Stonehill Offsite Water Extension Phase II
Solicitation Number: CO-00719
Job No.: 23-7003

ADDENDUM 2
November 21, 2023

PLAT NO. N/A
 JOB NO. 12747-00
 DATE NOVEMBER 2023
 DESIGNER CN
 CHECKED SG DRAWN JD
 SHEET C3.00

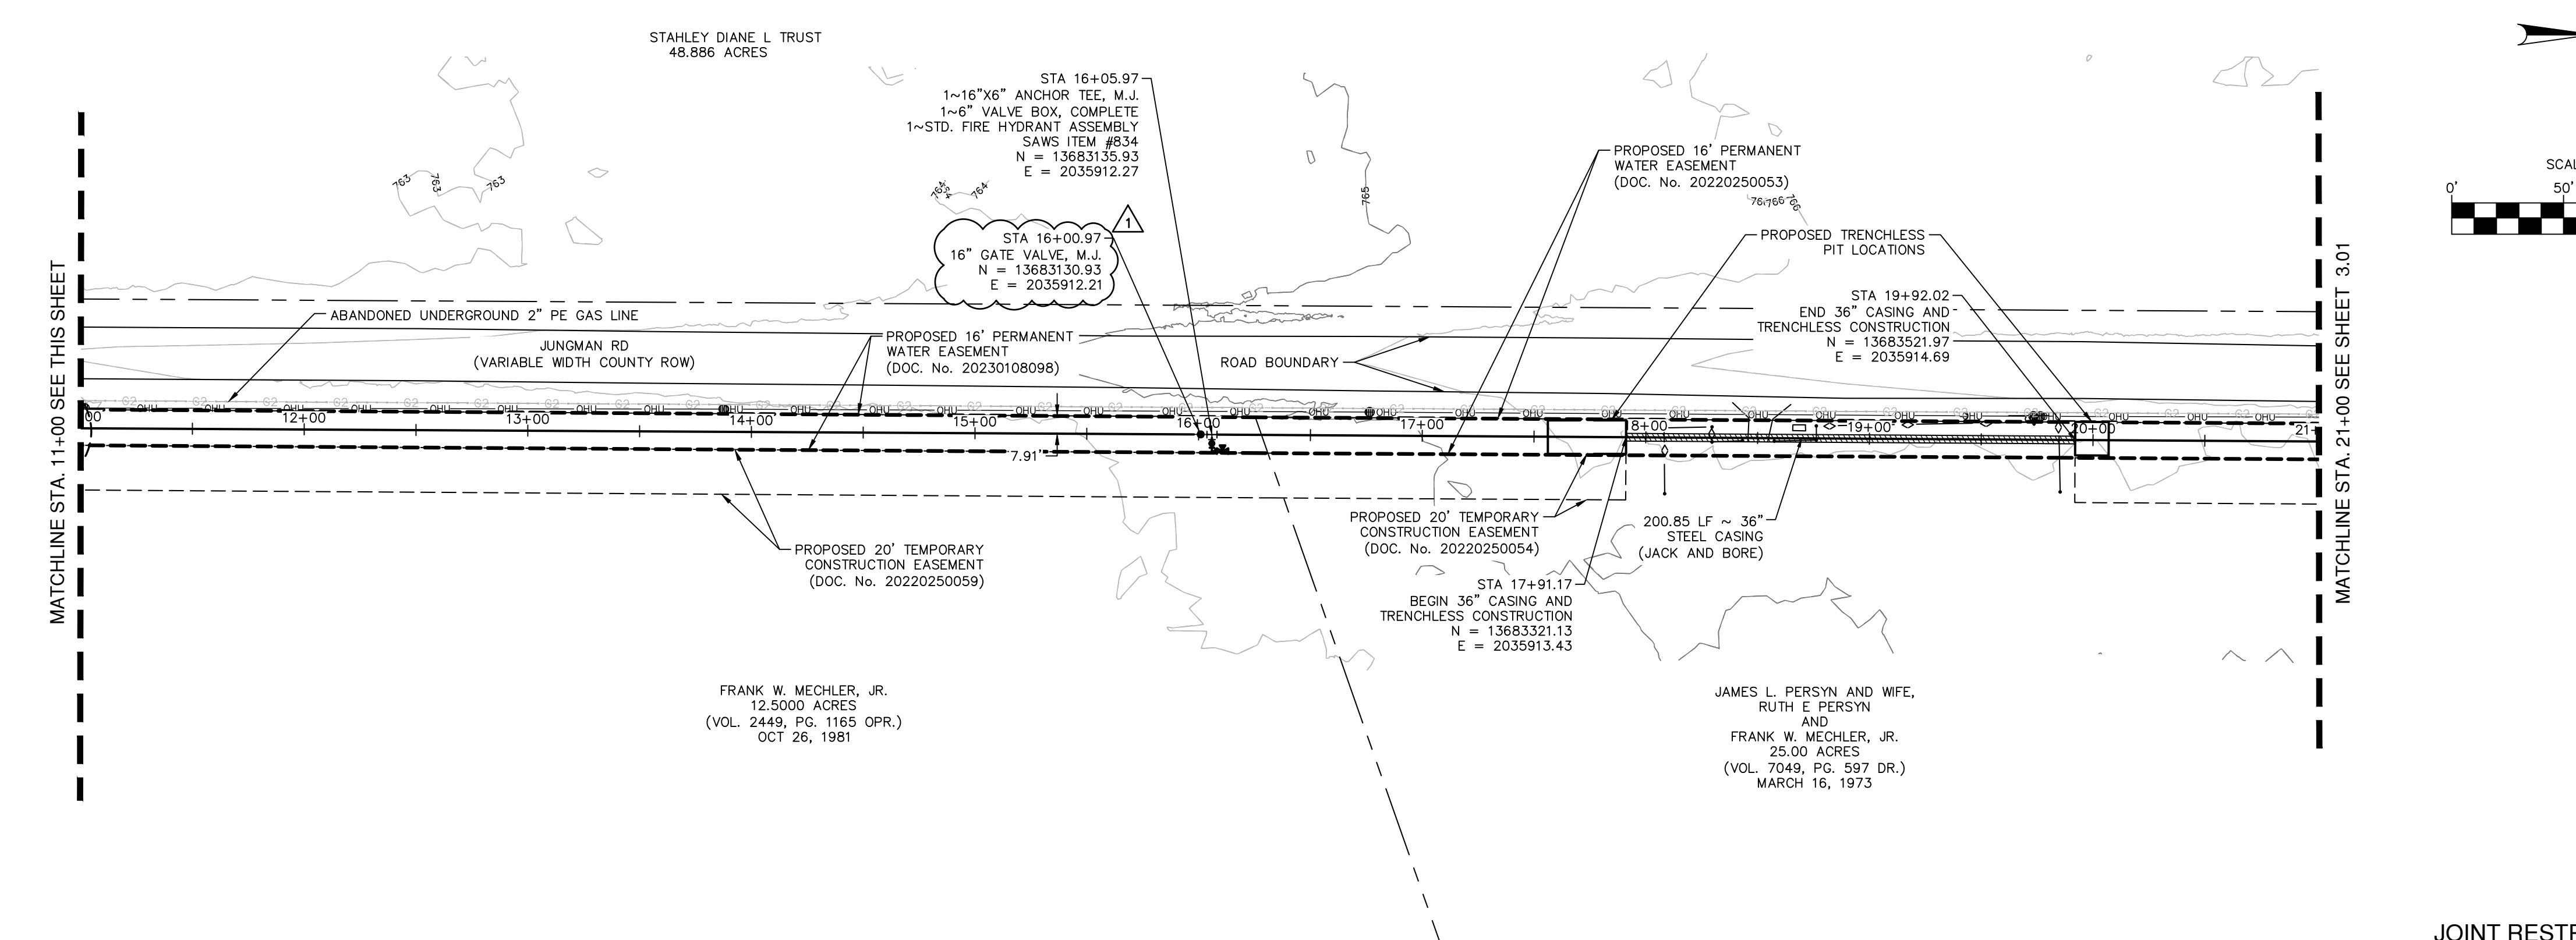
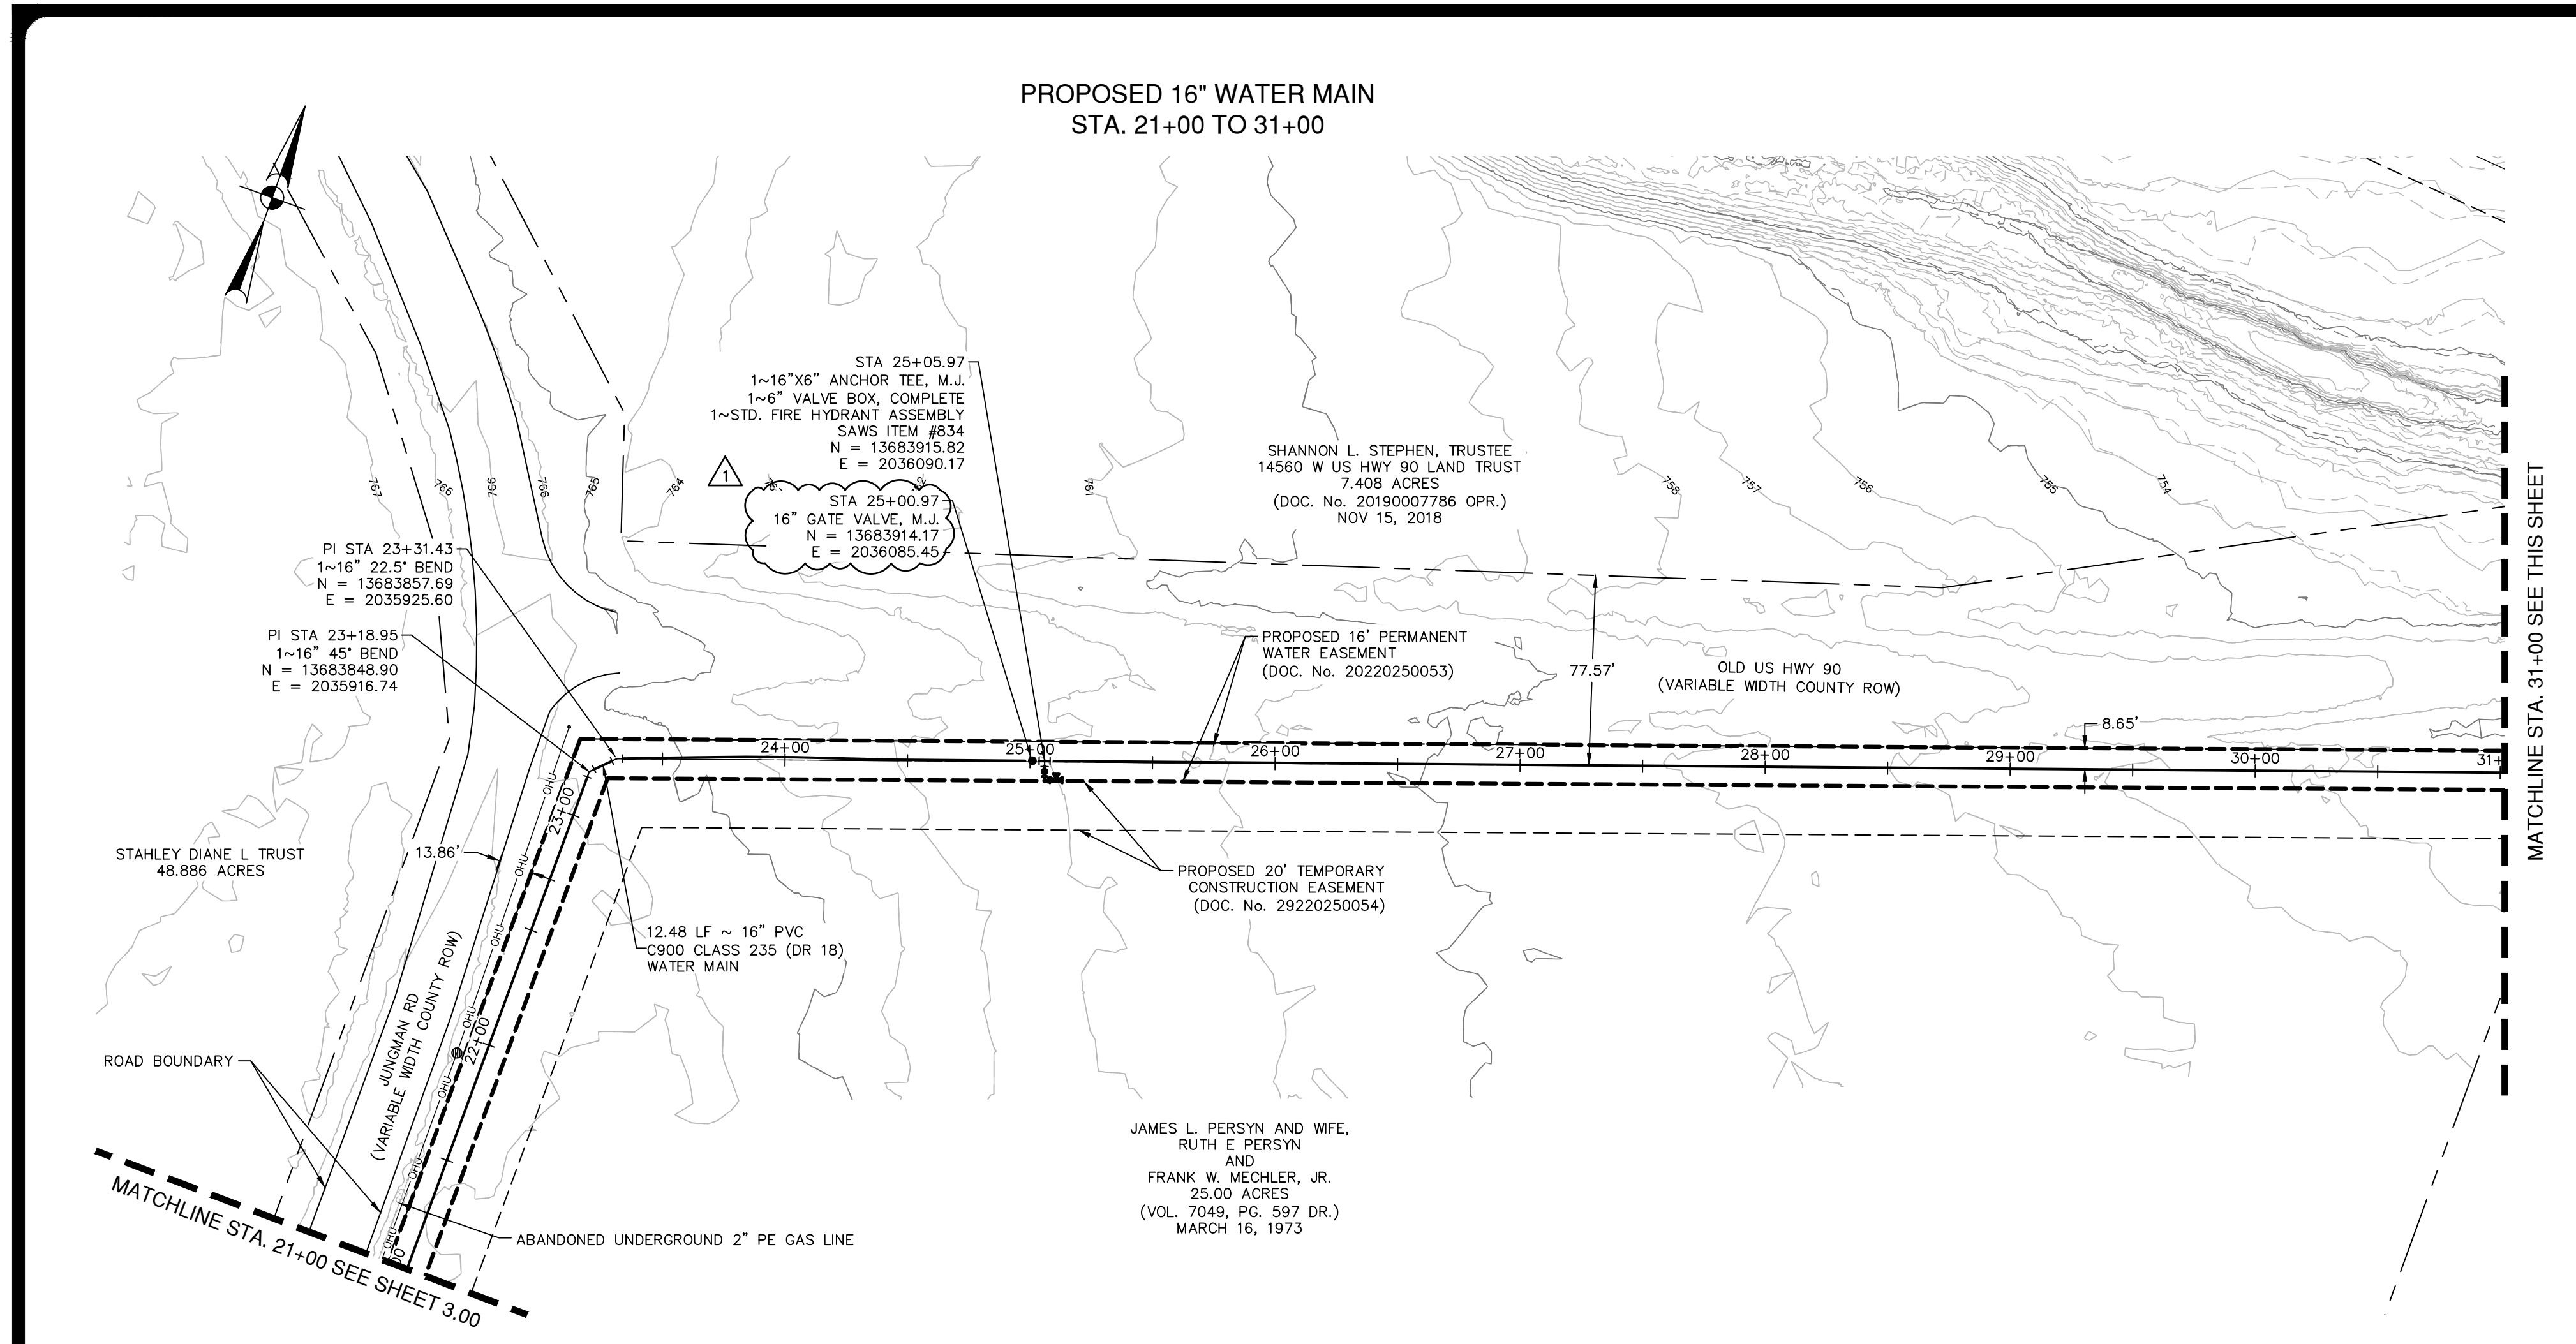
- 4. Question: In the bid schedule there's only a bid item for 4" temporary blowoffs. Under what bid item does the 2" temporary blowoff go as mentioned in the disinfection notes on plan sheet C3.00 – middle left?**

Response: See Changes to the Specifications #3. The Bid Form has been revised to include a line item for 2" blowoffs.
- 5. Question: Are the 4" blowoffs just at the end of the 24" line and the 2" blowoffs just at the end of the 8" and 12" lines? If so, should a bid item be added for the 2" blowoffs?**

Response: Yes, that is correct. See Changes to the Specifications #3. The Bid Form has been revised to include a line item for 2" blowoffs. See Changes to the Plans #2. The plans have been revised accordingly.
